TRC AGENDA

CITY OF DELAND
THURSDAY NOVEMBER 17, 2022 AT 1:30 P.M.
CITY OF DELAND TRC MEETING ROOM
DELAND, FLORIDA

Issues for record SP22-131
Job Address: 0 S Woodland BLVD,
Job Description: drive thru coffee shop

City of DeLand
TRC
SP22-203
NOVEMBER 17, 2022

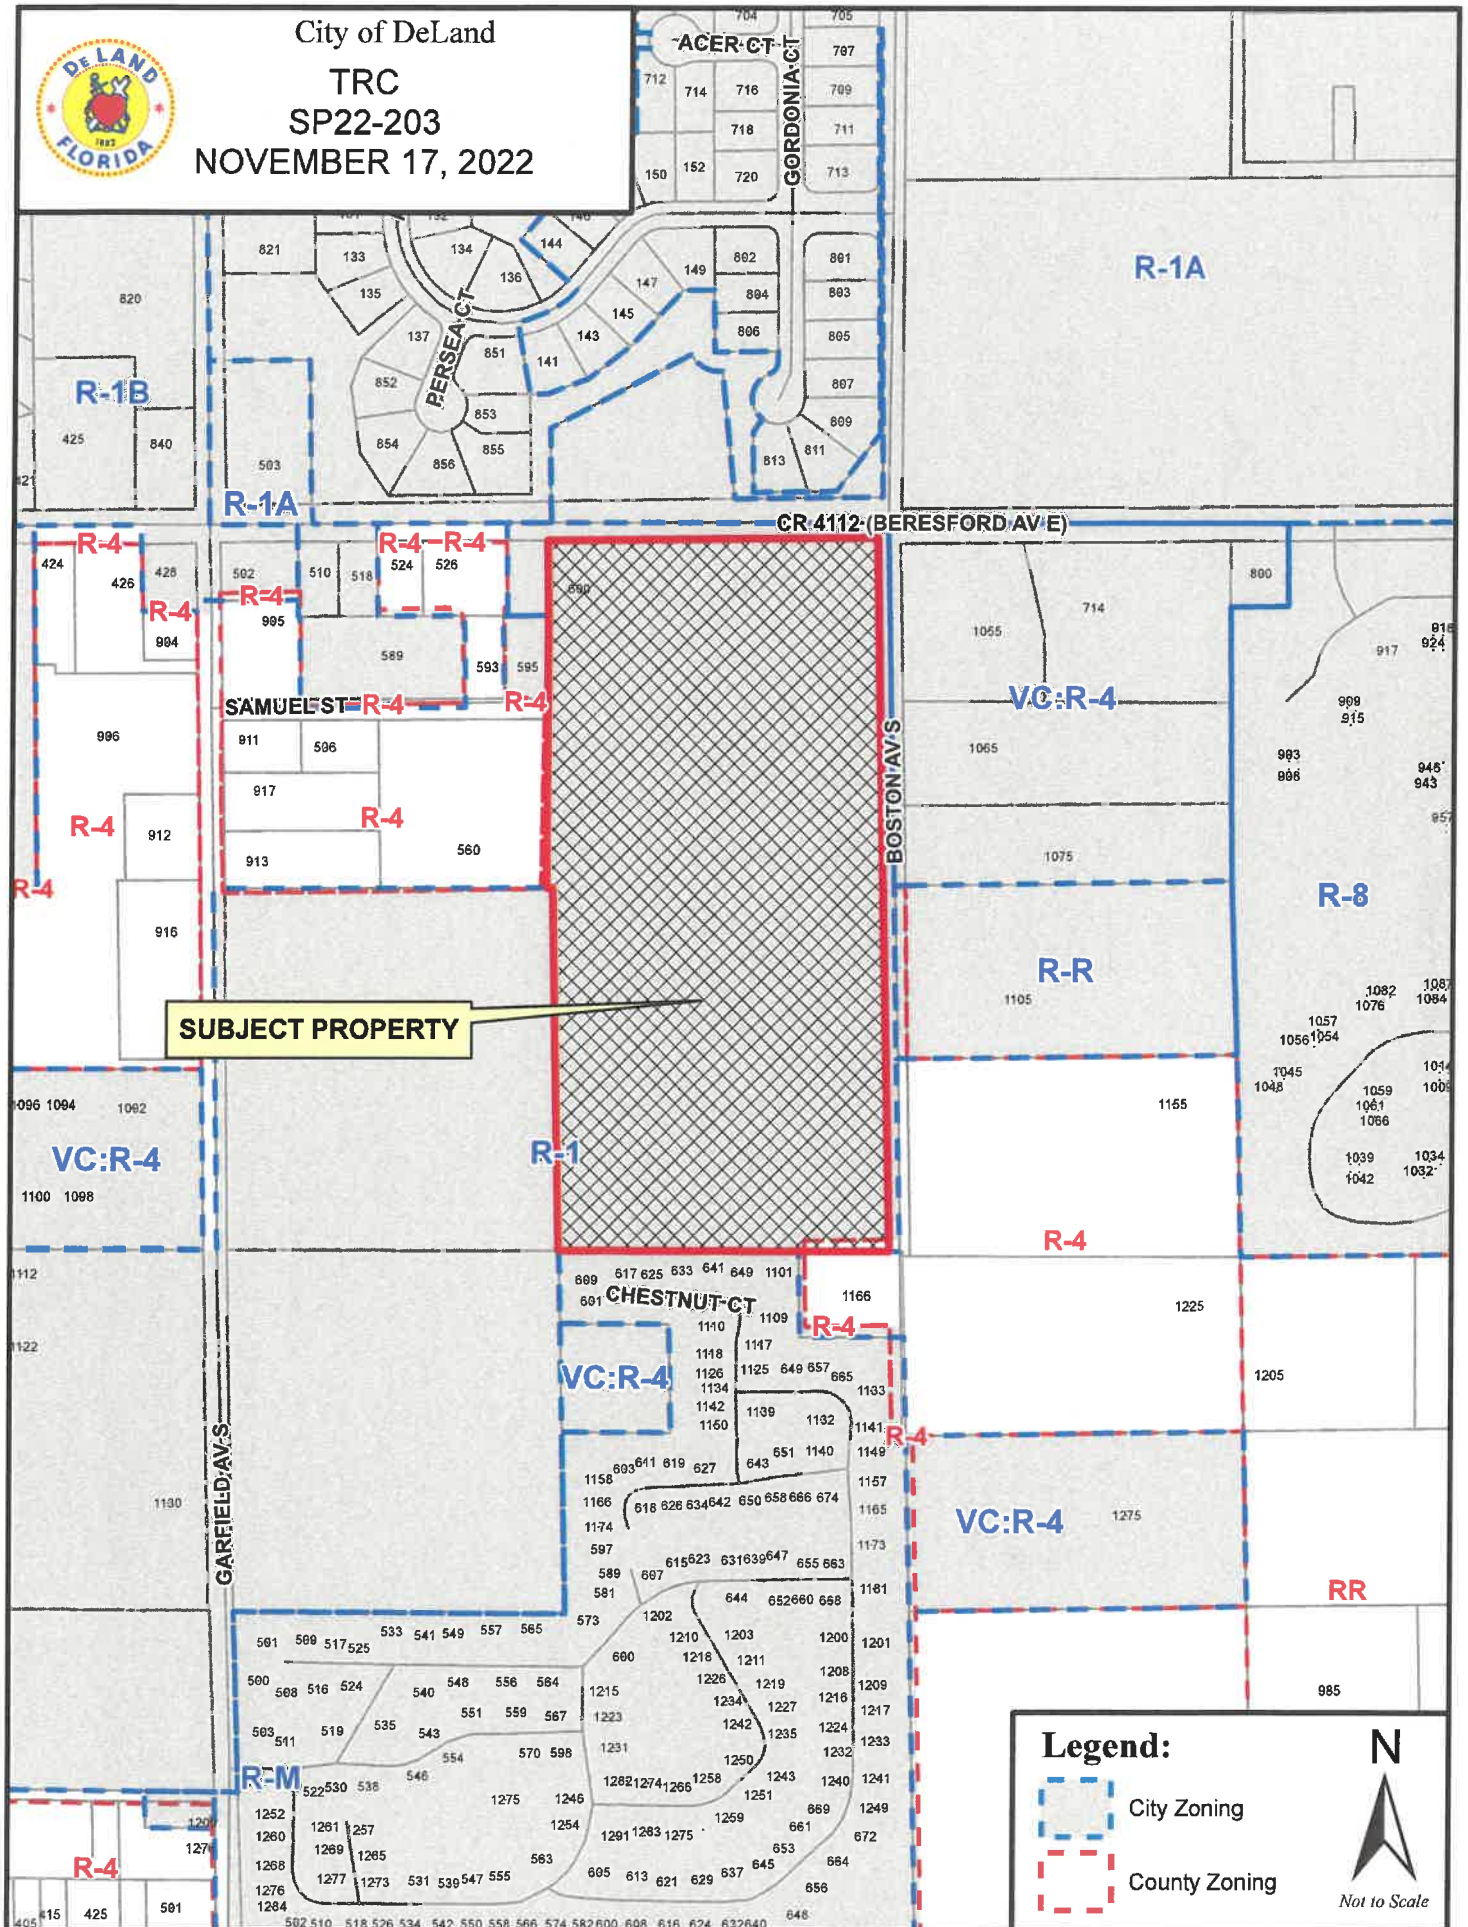
Discipline	Status	Details	Attached To	Created By	Last Updated By	Modifications Required
General Comments						
Engineering	Draft	- This development is adjacent to Beresford Ave. (County Road 4112) and S. Boston Ave.; therefore, Volusia County Use Permit is required. - Please provide a copy of SJRWMD / FDEP permit or letter modification upon approval. This is required prior to scheduling a pre-construction meeting.		Tuan Huynh	Tuan Huynh	Yes
Mitered End Sections (MES)						
Engineering	Draft	- Please show rip-rap rubble or equivalent at end of the mitered end (MES) sections for erosion protection. - Show MES end point terminating at bottom of the retention contour (29.0) and not across the bottom of the pond or along the bank slope.	C-4	Tuan Huynh	Tuan Huynh	Yes
Pop-off Bubbler						
Engineering	Draft	Provide invert elevation that the pop-off bubbler will discharge at.	C-4	Tuan Huynh	Tuan Huynh	Yes

Sidewalk Callout						
Engineering	Draft	Provide width and length dimensions for the proposed perimeter sidewalk. Note on plan sheet that sidewalk must be ADA compliance with max. 2% cross-slope and 5% longitudinal slope.	C-4	Tuan Huynh	Tuan Huynh	Yes
Insufficient Tree Data Provided						
Forestry	Draft	- No tree survey, landscape plan, or irrigation plan have been provided. - Tree Barricade Detail has not been provided. - No tree worksheets have been provided. - No Tree Protection Area has been identified. - A survey has been provided that identifies the project area as "heavily wooded." - Additional comments will be provided when required data has been provided.	CS100	Mariellen Calabro	Mariellen Calabro	Yes
Text under legal description						
Forestry	Draft	Remove "Public Works Department."	C-1	Mariellen Calabro	Mariellen Calabro	Yes

Discipline	Status	Details	Attached To	Created By	Last Updated By	Modifications Required
Planning	Draft	Dimensions				
		Show dimensions of Mausoleum		Danevsky Joseph	Danevsky Joseph	Yes
Planning	Draft	Setbacks				
		Show setbacks		Danevsky Joseph	Danevsky Joseph	Yes
Planning	Draft	Matching				
		Make sure color and arch match existing structure		Danevsky Joseph	Danevsky Joseph	Yes

City of DeLand
TRC
SP22-211
NOVEMBER 17, 2022

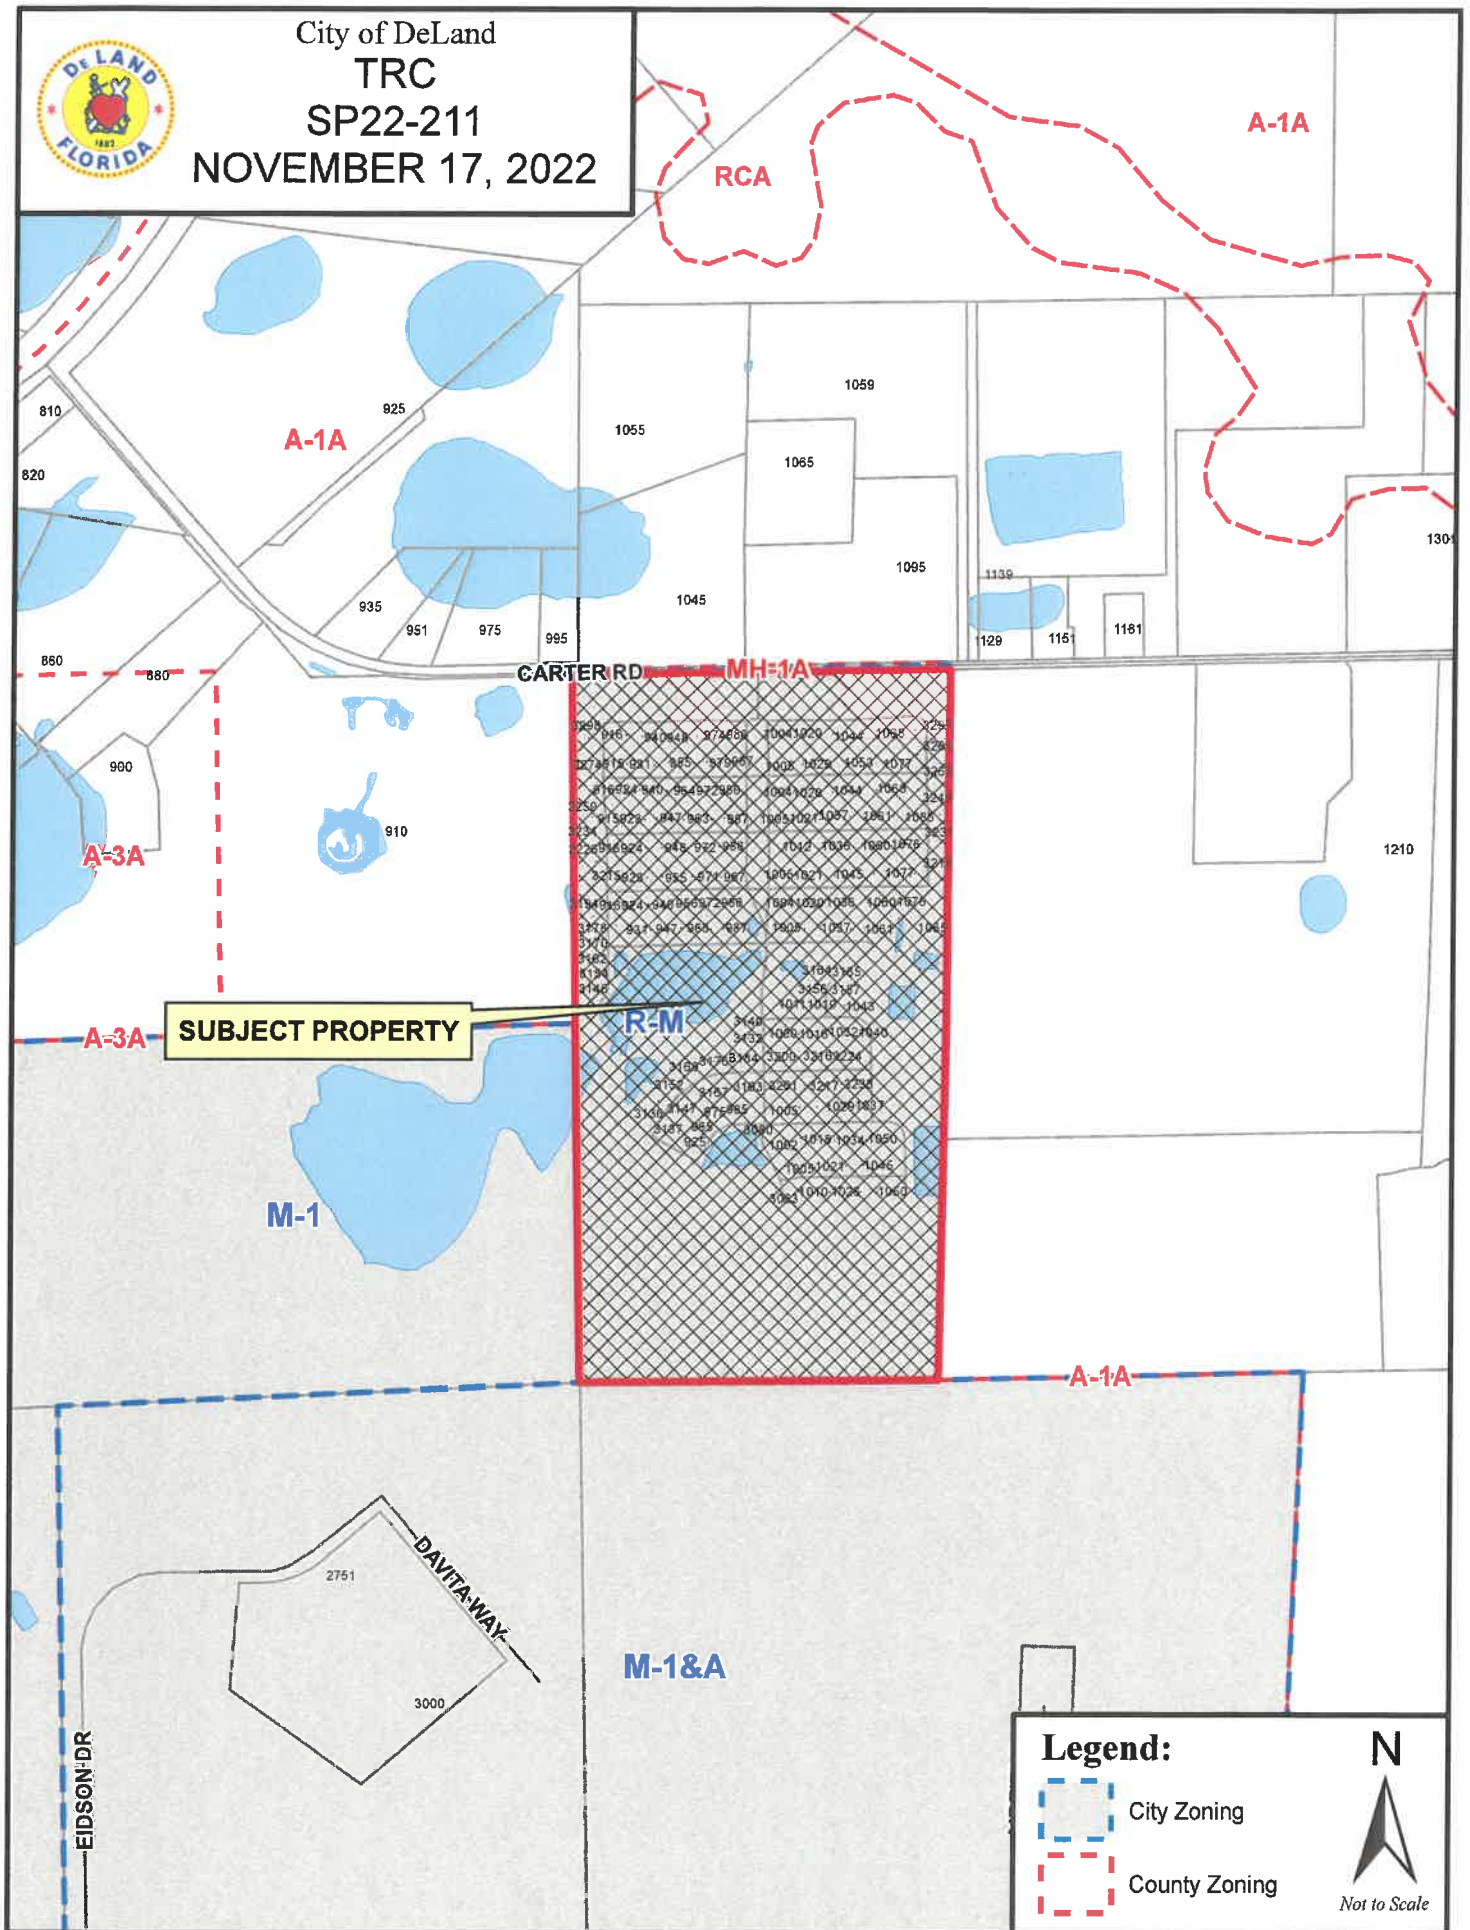
Discipline	Status	Details	Attached To	Created By	Last Updated By	Modifications Required
Drainage Calculations						
Engineering	Draft	1. Proposed wet ponds (for site over one acre) must be designed for the 25yr-24hr storm event per LDC, Section 33-93.06 stormwater management requirements. Drainage report submitted show the ponds are sized only for treatment volume and not the attenuation volume. Provide pond routing calculations for the 25yr-24hr storm (8.6" rainfall) to demonstrate that the post-development discharge rate and volume are less than pre-development. 2. Are the wet ponds designed with positive discharge off-site or closed basins? Please show more clearly on the construction plans and stormwater report calculations. Please note 100yr-24hr and 25yr-96hr storms pond routing are required for closed basin (no discharge).		Tuan Huynh	Tuan Huynh	Yes
Typical Pavement Section						
Engineering	Draft	1. Base alternative, please revise to "Graded Crushed Aggregates (Crushed Concrete)". 2. Please callout "SOD" for the 5' wide strip outside the roadway pavement area.	C002	Tuan Huynh	Tuan Huynh	Yes

General Comments						
Engineering	Draft	1. Please provide a copy of SJRWMD / FDEP permit for the stormwater management system upon approval. This is required prior to scheduling a pre-construction meeting.		Tuan Huynh	Tuan Huynh	Yes
Pond Skimmer						
Engineering	Draft	1. Please show skimmer with top and bottom elevations for each wet pond control structure. Please refer to current FDOT Standard Plans Index 425-070 and include this index in the plan set.	C004	Tuan Huynh	Tuan Huynh	Yes
Pond Sod Limits						
Engineering	Draft	1. Wet ponds are typically sod to a point two feet below the seasonal high water table (SHWT). Plans callout sod all side slopes.	C004	Tuan Huynh	Tuan Huynh	Yes

Discipline	Status	Details	Attached To	Created By	Last Updated By	Modifications Required
Pond Outfall System						
Engineering	Draft	1. It is not clear where the proposed outfall location is for each wet pond. Please show the control structure and its outfall pipe for each pond.	C005	Tuan Huynh	Tuan Huynh	Yes
Secondary Storm System						
Engineering	Draft	1. Please show the secondary storm sewer systems (pipes and inlets) on the grading plan.	C005	Tuan Huynh	Tuan Huynh	Yes
Street Grades High Points						
Engineering	Draft	1. Please show stationing grade break points (high points) along the streets with flow arrows in addition to the lot grading arrows.	C005	Tuan Huynh	Tuan Huynh	Yes
Hydrants						
Fire	Draft	Hydrant spacing exceeds 800 feet. Additional hydrants will be needed.	C007	Jamie Lunsford	Jamie Lunsford	Yes
Egress						
Fire	Draft	Due to overall size of development, a second means of egress / exit will be required.	C001	Jamie Lunsford	Jamie Lunsford	Yes

Roadway						
Fire	Draft	Identify the width of the one-way roadways where indicated.	C006	Jamie Lunsford	Jamie Lunsford	Yes
Tree Species without DBH						
Forestry	Draft	Twin Oak, Triple Oak, Twin Pine, etc. are not appropriate measurements for Trees 1763, 1766, 2165, 2168, 2171, 2174, 2198, 2205, 2213, 2220, 2226, 2294, 2295, 2298, 2313, 2315, 2320, 2327, 2433, 2435, 2438, 2439, 2441, 2442, 2446, 2447, 2470, 2483, 2491, 2495, etc.	C009	Mariellen Calabro	Mariellen Calabro	Yes
Tree Preservation Area						
Forestry	Draft	Change Tree Preservation Area to Tree Protection Area to be consistent with Code Language.	C006	Mariellen Calabro	Mariellen Calabro	Yes
Tree Protection Areas						
Forestry	Draft	TPA 3.0 and TPA 2.0 do not appear to have sufficient existing trees to be considered TPA. You will need to plant additional trees to make sure that you have at least one tree per 2,500 sf.	C008	Mariellen Calabro	Mariellen Calabro	Yes

Discipline	Status	Details	Attached To	Created By	Last Updated By	Modifications Required
Forestry	Draft	Tree Preservation Area Change Tree Preservation Area to Tree Protection Area.	C008	Mariellen Calabro	Mariellen Calabro	Yes
Forestry	Draft	Minimum coverage Based on the information provided, your project would have at least 2,720" DBH remaining. If your project area is 384,297 sf, you would meet the minimum coverage requirement of 922" DBH.	C009	Mariellen Calabro	Mariellen Calabro	Yes
Forestry	Draft	Tree 1388 Is this tree removed or remaining. The number is shaded, but the size is not.	C009	Mariellen Calabro	Mariellen Calabro	Yes
Forestry	Draft	Tree Calculations Your tree calculations do not appear to be correct. 1. All trees that are not specifically exempted by the Code require replacement, not just oaks 2. You have not identified oaks and pines by species. Some oaks and pines may be specimen trees, which would require one half diameter replacement instead of one third. 3. You need to provide specifications for trees to be provided. Specifications need to include species, container size, height, spread and caliper. 4. DBH is not the same as caliper. In general, 3-inch caliper trees would provide 2 inches DBH of replacement. If you are providing 206 trees that are 3" caliper, your plan would provide 412" DBH. 5. I don't understand your calculations on the last two lines. We need to figure out the number of inches removed and the number of replacement inches provided. Once we have that number, we would subtract 412 from that number to determine your deficiency. If you cannot plant additional trees on the property, you will need to contribute \$75 per inch not planted into the Tree Replacement Reserve Account.	C009	Mariellen Calabro	Mariellen Calabro	Yes

Forestry	Draft	Tree Specifications Provide specifications for trees to be planted.	C009	Mariellen Calabro	Mariellen Calabro	Yes
Forestry	Draft	Tree Replacement I cannot calculate tree replacement without additional information.	C009	Mariellen Calabro	Mariellen Calabro	Yes
Forestry	Draft	Tree Protection Areas Tree Protection Areas need to have at least one tree per 2,500 sf. The wetland area TPA 3.0 does not appear to meet this requirement.	C006	Mariellen Calabro	Mariellen Calabro	Yes

Discipline	Status	Details	Attached To	Created By	Last Updated By	Modifications Required
ID Trees by species						
Forestry	Draft	Oak trees and pine trees need to be identified by species to determine whether you have any specimen trees. Because they have not been identified and because several trees do not have diameters listed, I cannot determine impacts and replacement requirement for this project.	C009	Mariellen Calabro	Mariellen Calabro	Yes
Tree Worksheets						
Forestry	Draft	Please provide tree worksheets for the project. Please also provide the information presented on this page in excel format to allow for easier review.	C009	Mariellen Calabro	Mariellen Calabro	Yes
Tree Barricade Detail						
Forestry	Draft	Replace graphic with City Standard Tree Barricade detail.	C010	Mariellen Calabro	Mariellen Calabro	Yes
Landscape Plan						
Forestry	Draft	Provide Landscape Plan for the project.	C001	Mariellen Calabro	Mariellen Calabro	Yes

Irrigation Plan						
Forestry	Draft	Provide Irrigation Plan for the project.	C001	Mariellen Calabro	Mariellen Calabro	Yes
TPA						
Planning	Draft	Indicate the amount of tree protection area provided on the cover sheet (or sheet C006).	C001	Belinda Collins	Belinda Collins	Yes
Drainage Basin 4						
Planning	Draft	Clearly indicate the northern boundary of drainage basin #4.	C005	Belinda Collins	Belinda Collins	Yes
Wetland buffer encroachment						
Planning	Draft	A portion of the planned roadway along Meadowlea Dr. encroaches into the wetland buffer area. Disturbance of the wetlands is discouraged and no net loss of wetland area is permitted. An application for an environmental resource permit from FDEP should be submitted. The wetland is greater than 2 acres in size and is therefore not exempt from the requirements of the land development code. A wetland alteration permit from the city is required to impact this wetland. Identify the solution to be provided for the encroachment of the road into the wetland/wetland buffer areas.	C006	Belinda Collins	Belinda Collins	Yes

Age restricted community						
Planning	Draft	Verify whether or not this is still a 55+ community. Allowing school aged residents here will require a review by the VCSB.	C001	Belinda Collins	Belinda Collins	Yes

Discipline	Status	Details	Attached To	Created By	Last Updated By	Modifications Required
Acreages						
Planning	Draft	7. General Note #16 – switch the acreage numbers to accurately identify the size of the phases.	C001	Belinda Collins	Belinda Collins	Yes
Biological Survey						
Planning	Draft	The Biological Survey Report indicates that the survey conducted in January of 2022 is valid for 90 days, a total of 9 gopher tortoise burrows were observed on-site and that 4 options were available to address the presence of tortoises. Indicate the selected option to address the situation and provide the timeframe for the re-survey of the area.	C001	Belinda Collins	Belinda Collins	Yes
Label						
Planning	Draft	Correct the label for Drainage basin #1 to indicate the numeral 1 instead of numeral 4.	C005	Belinda Collins	Belinda Collins	Yes
Water Main size						
Utilities	Draft	Where does the 4" water main end and the 6" water main begin?	C007	Scott Zender	Scott Zender	Yes

Water General						
Utilities	Draft	Callout valves and fire hydrants and show on plan set.	C007	Jim Ailes	Jim Ailes	Yes
Water service						
Utilities	Draft	No service shown.	C011	Jim Ailes	Jim Ailes	Yes
Hydrant						
Utilities	Draft	Hydrant can not be connected to a 4" water main 6" water main is minimum.	C007	Scott Zender	Scott Zender	Yes
General Note 20						
Utilities	Draft	Confirm Fire Department is ok with this separation.	C001	Jim Ailes	Jim Ailes	Yes
Fire protection Note #2						
Utilities	Draft	confirm Fire Department is good with this separation.	C001	Jim Ailes	Jim Ailes	Yes
Reuse						
Utilities	Draft	Plans show no connection to reuse water for irrigation. A 12" reuse line is locate by water and sewer lines.	C007	Jim Ailes	Jim Ailes	Yes

Discipline	Status	Details	Attached To	Created By	Last Updated By	Modifications Required
Utilities	Draft	Agreement A Utility Service Agreement will be required for this project.	C001	Jim Ailes	Jim Ailes	Yes
Utilities	Draft	Water Service No water service line shown	C012	Jim Ailes	Jim Ailes	Yes
Utilities	Draft	Sewer No lateral shown	C016	Jim Ailes	Jim Ailes	Yes
Utilities	Draft	Sewer No lateral shown	C018	Jim Ailes	Jim Ailes	Yes
Utilities	Draft	Lift Station Private or City?	D004	Jim Ailes	Jim Ailes	Yes
Utilities	Draft	Sewer No lateral for sewer shown.	C012	Jim Ailes	Jim Ailes	Yes
Utilities	Draft	Sewer No lateral	C013	Jim Ailes	Jim Ailes	Yes
Utilities	Draft	Sewer Connection Where is the sewer main connecting to the existing sewer main? Show type of connection and fittings. There is already an 8" stub out for this location for gravity.	C007	Scott Zender	Jim Ailes	Yes
Utilities	Draft	Water Main Connection Where are you connecting the water main to the existing water main at? Show type of connection and fittings.	C007	Scott Zender	Jim Ailes	Yes

Discipline	Status	Type	Details	Attached To	Created By
Utilities	Draft	Note	Hydrants Are there any hydrants being installed if so where are they located?	C007	Scott Zender
